CITY OF WICHITA

Wichita-Sedgwick County Metropolitan Area Planning Department

Re: **BZA2026-00026:** Administrative Adjustments in the City to reduce the southeast compatibility setback from 15 feet to 2.5 feet including a reduction of the corresponding street side setback from 5 feet to 2.5 feet (50 percent) for construction of a trash enclosure on property zoned B Multi-Family Residential District, generally located on the north side of East Pawnee Avenue and within one-block east of South Rock Road (8200 East Pawnee Avenue).

WATERCREST AT CHERRY CREEK TRASH ENCLOSURE

1 **SITE PLAN - ADMINISTRATIVE ADJUSTMENT**
1" = 30'-0"

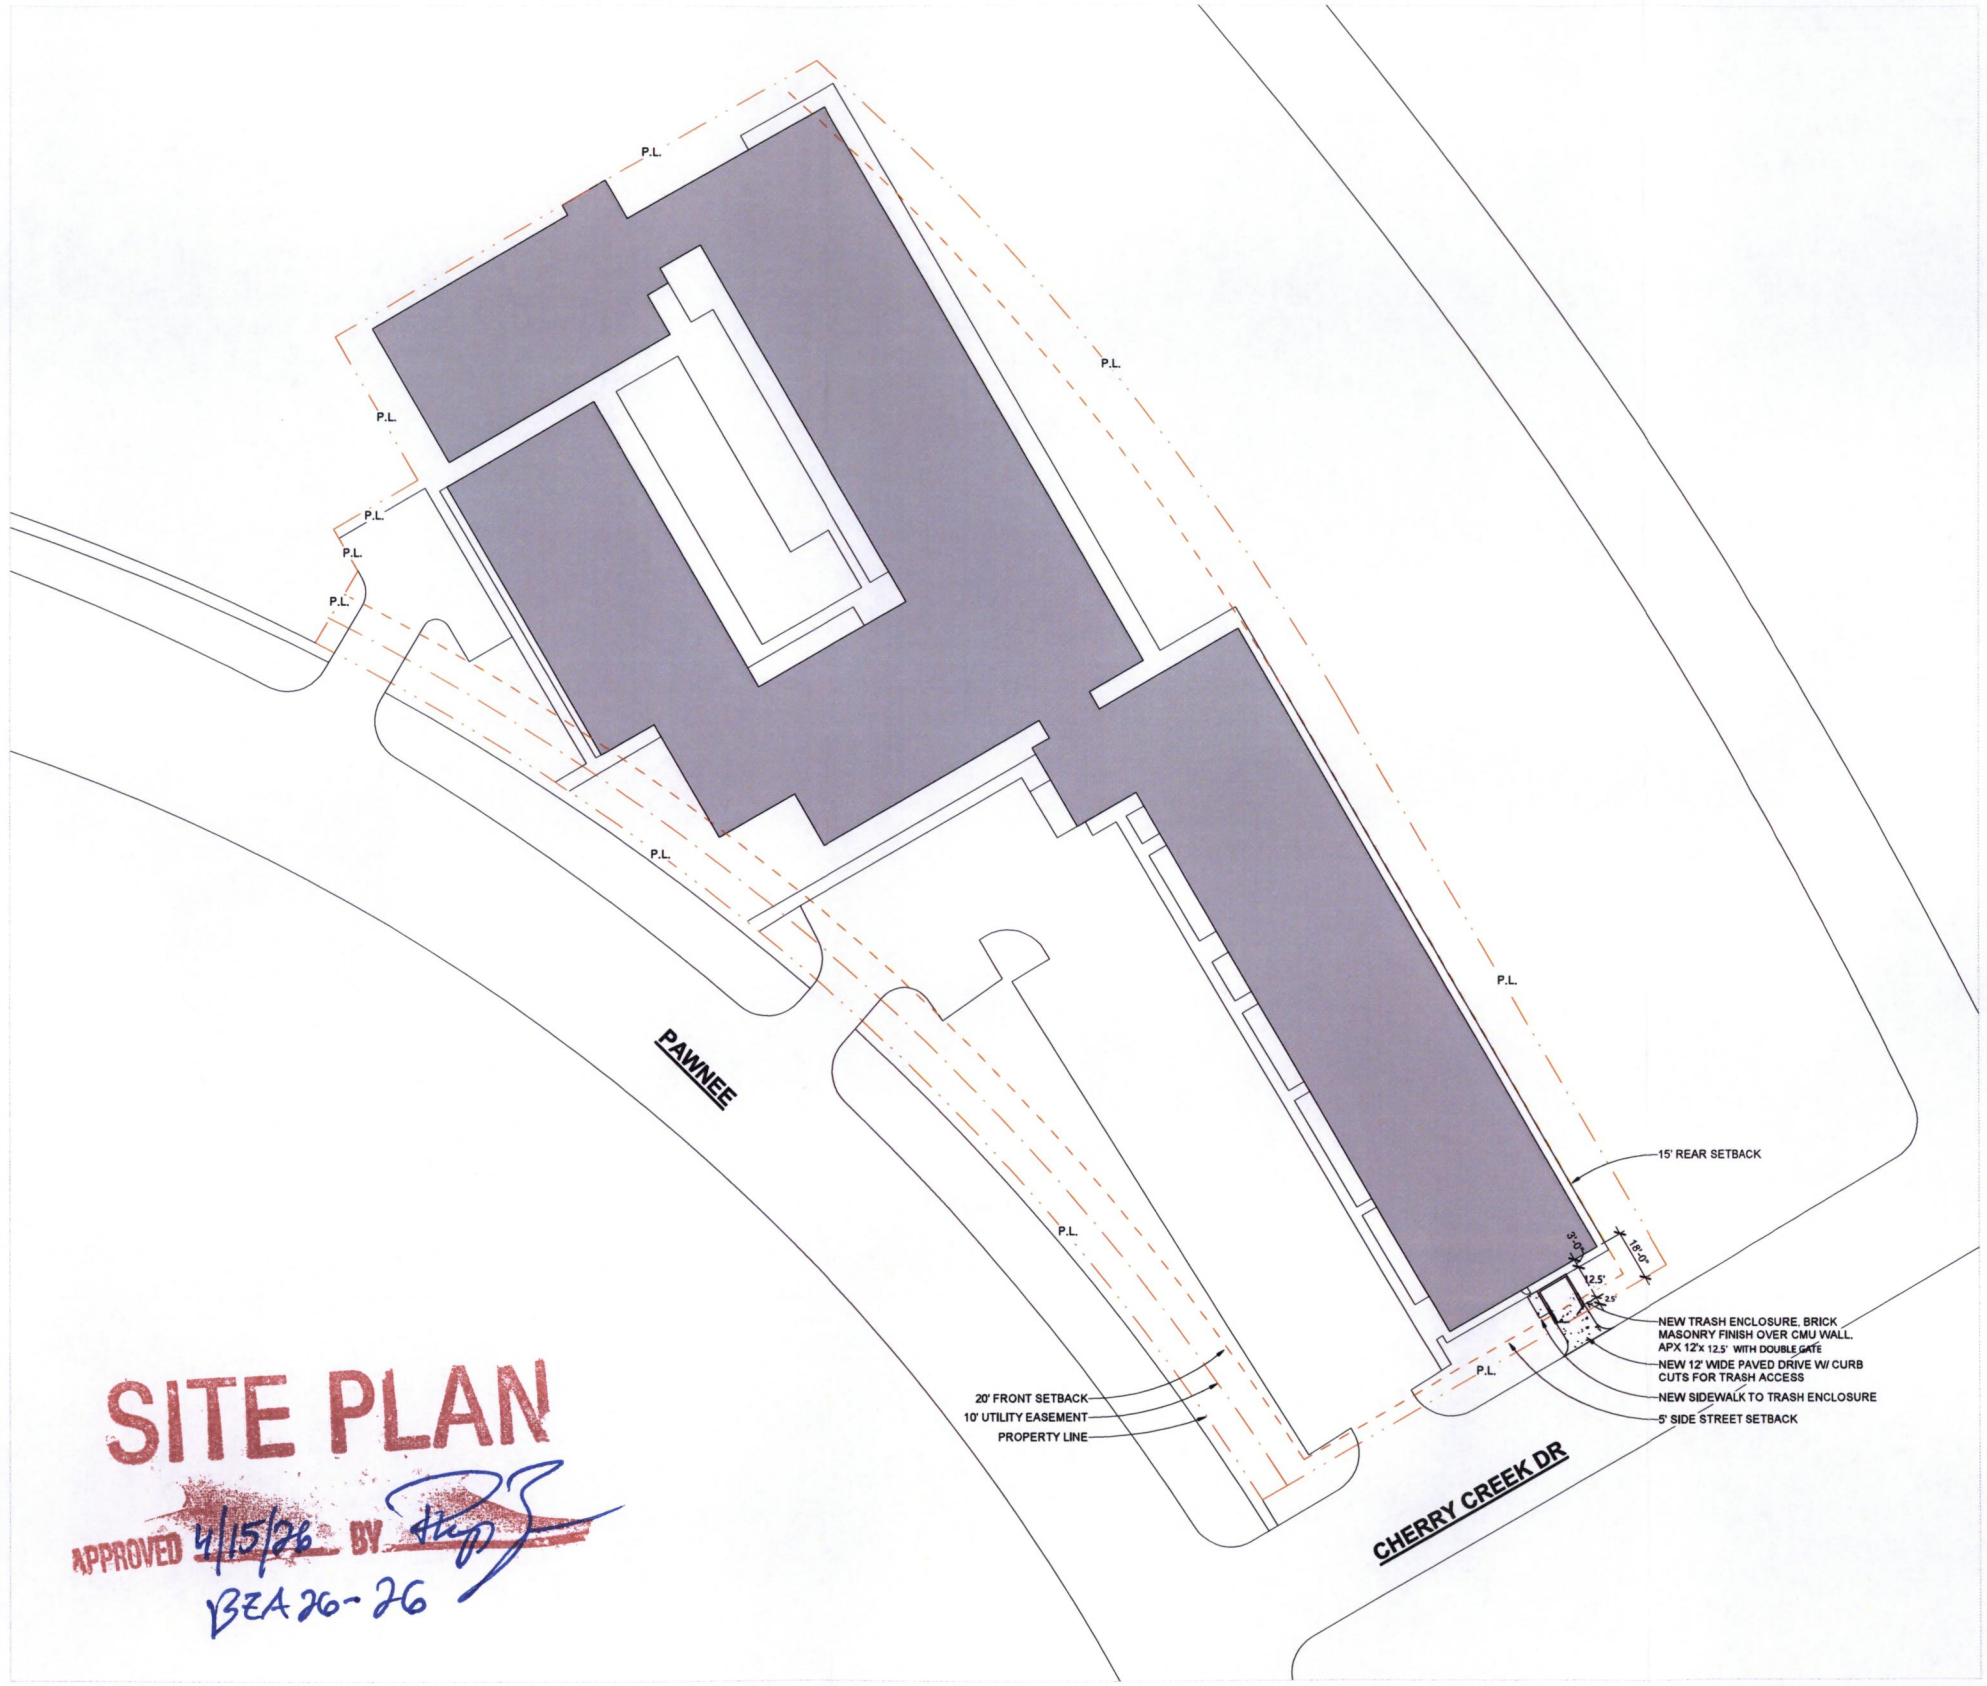
We have reviewed your request for Zoning Adjustments to reduce the southeast compatibility setback from 15 feet to 2.5 feet including a reduction in the corresponding street side setback from 5 feet to 2.5 feet (50 percent) for an area less than 300 square feet on the aforementioned property in order construct a trash enclosure. The site plan indicates the trash enclosure would be on the south side of the eastern-most building. The trash enclosure would provide 3 feet of separation from the building and is proposed to be 12.5 feet by 12.5 feet. The total area of encroachment would be 25 square feet.

Section IV-C.4 of the Unified Zoning Code ("UZC") requires a 15-foot compatibility setback along the side lot line when adjacent to property zoned TF-3 or more restrictive. Properties to the east, across East Cherry Creek Drive are zoned TF-3 and developed with duplexes. In order to reduce the standard building setback from 5 feet to 2.5 feet as described above, a reduction in the compatibility setback is required as well.

Our signatures below indicate that the Zoning Adjustments to reduce the southeast compatibility setback from 15 feet to 2.5 feet and the corresponding street side setback from 5 feet to 2.5 feet for an area less than 300 square feet are hereby GRANTED, subject to the following conditions:

3) The setback reduction shall apply only to the 2.5-foot southeast street side setback as illustrated on the approved site plan. All other structures or additions on the subject property shall conform to the setbacks permitted by the Unified Zoning Code unless a separate Zoning Adjustment or Variance is granted.

1) The site shall be developed in general conformance with the approved site plan.
